No Build/TSM Alternative

Light Rail Alternative-Initial Operating Segment

Light Rail Alternative-New Central Subway

FIGURE 2-8

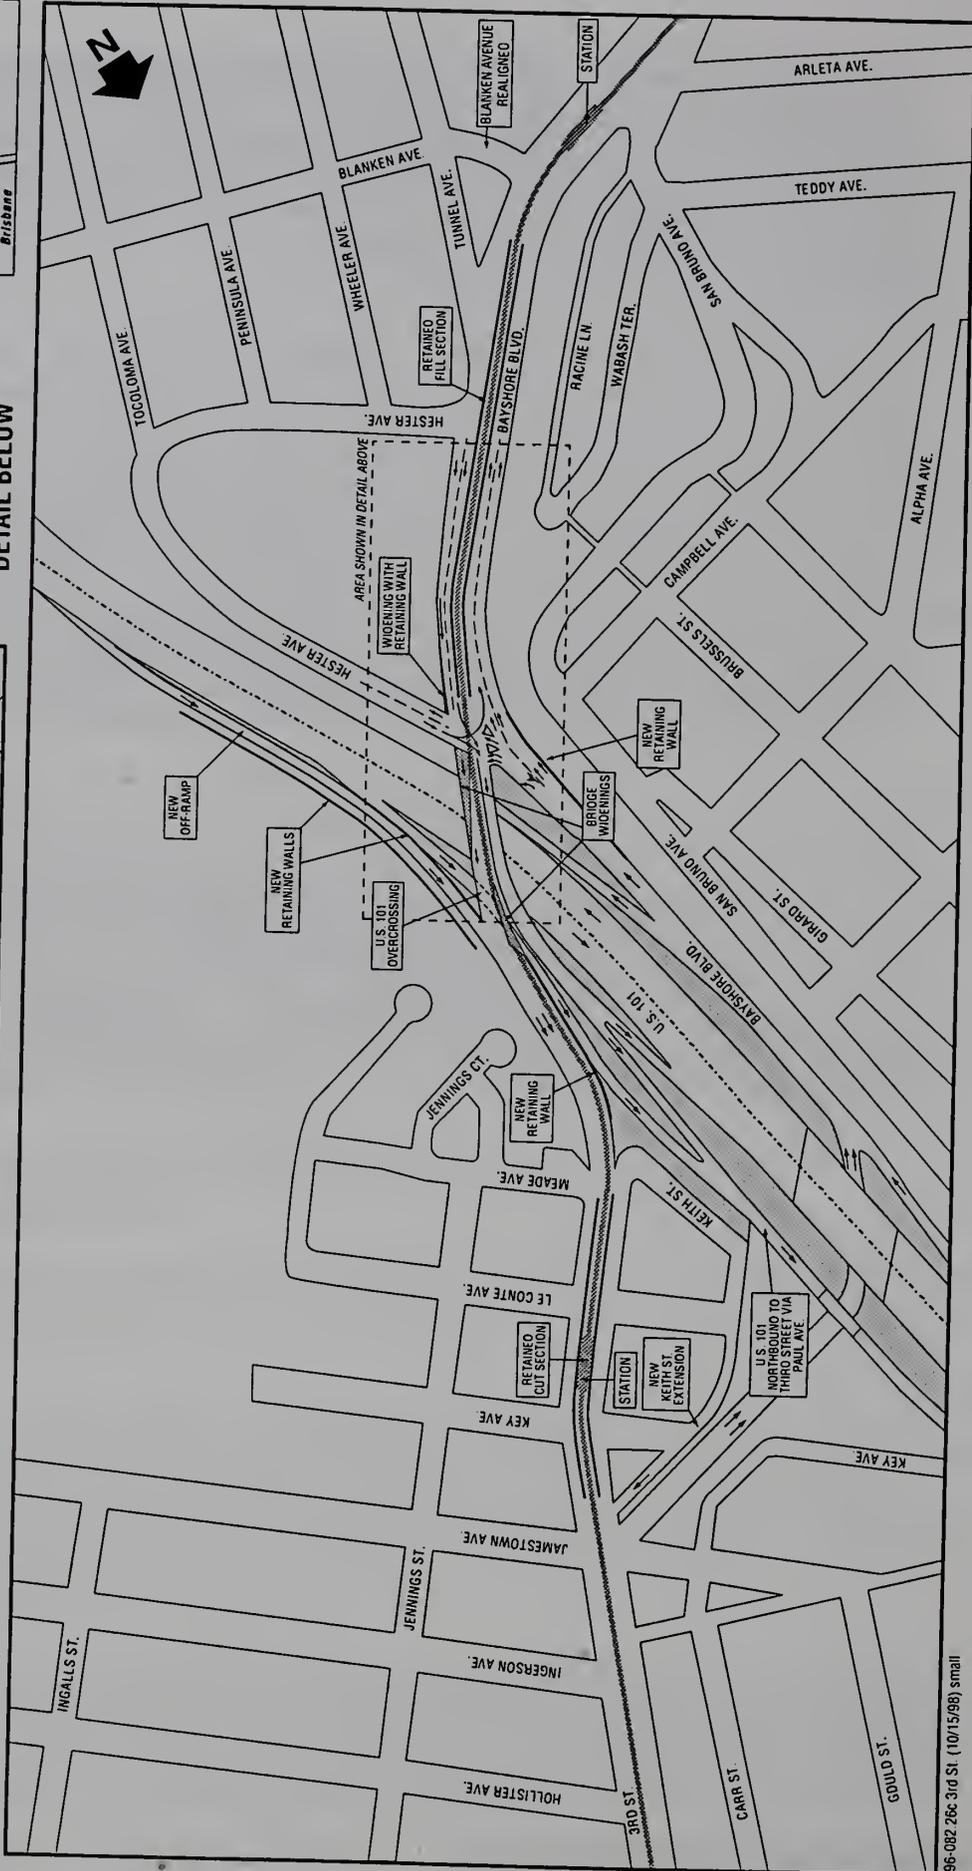
To mitigate this significant adverse impact, the Draft EIS/EIR appears to recommend that the #2 southbound lane "be delineated to serve both left-turning and through vehicles (if deemed feasible during final design)" (page 3-47). No alternative mitigation is offered if this is not deemed feasible, and it is questionable how traffic flow is improved by potentially impeding one of only two through lanes serving traffic from southbound Bayshore Boulevard and Third Streets, as well as the southbound Highway 101 off ramp (Figure 2-8).

Page 2-21 The description of the light rail alignment shifting to the east side of the Bayshore Boulevard right-of-way south of the Highway 101 overcrossing is inconsistent with page 2-58 (Figure 2-8) and page 2-45 (second bullet).

As noted in the “Staff Initiated Changes,” the proposed light rail alignment and traffic circulation in the area of the Highway 101 overcrossing has been revised (refer to “Staff Initiated Changes” E-3 and revised Figure 2-8). The revision, which would add turning lanes, provide lane delineation, and add new retaining walls, would improve the southbound left-turn movement to LOS D or better conditions during the a.m. and p.m. peak hours in 2015. The revised improvements were deemed feasible in the *US 101 and Third Street Overcrossing Draft Project Study Report/Project Report* (April 1998), available for review at the San Francisco Planning Department.

As indicated on page 2-21 in the DEIS/DEIR, approaching the Highway 101 overcrossing from the south, the light rail alignment would shift to the east in the Bayshore Boulevard right-of-way. The shift would allow northbound vehicles to be segregated into Third Street-bound traffic and Highway 101/Bayshore-bound traffic. This description is consistent with Figure 2-8 and the second bullet at the bottom of page 2-45.

The light rail alignment and traffic circulation in the area of the Highway 101 overcrossing is revised as follows (the fourth, fifth, and sixth paragraphs of page 2-21, Figure 2-8 on page 2-22, and Table 5-1 on page 5-8):

The proposed station at Third/Jamestown is changed to Third/Key. The first paragraph of page 2-23 and Figure 2-8 and Table 5-1 on page 5-8 are revised.

Figure 1. Aerial photograph showing the Project APE and locations of the proposed trolley poles

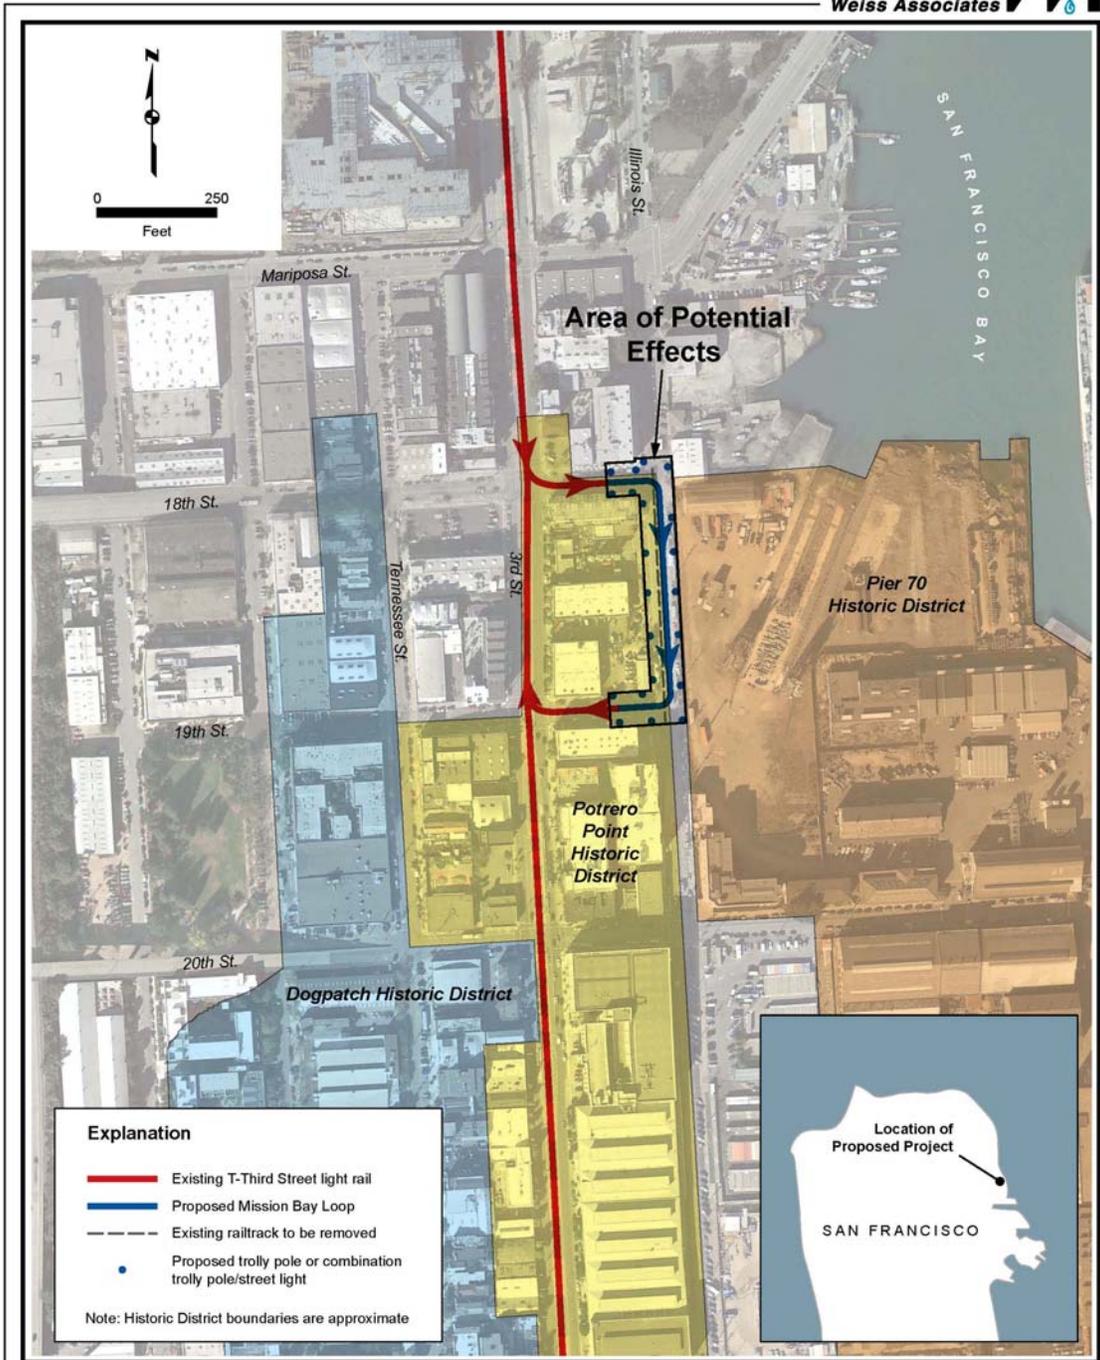
FTA has determined that the APE is 900 feet in length and includes the width of the street and sidewalk and street-light bulb-outs along one-third of the block of Eighteenth and Nineteenth Streets near the intersections with Illinois Street, and the width of the street along one full block of Illinois Street between Eighteenth and Nineteenth Streets, as shown in Figure 1 of the technical memo attached to your letter. The vertical APE extends to a maximum of ten feet below the surface for ground disturbance from the project work, including the installation of the proposed trolley poles/streetlights. I do not object to this APE.
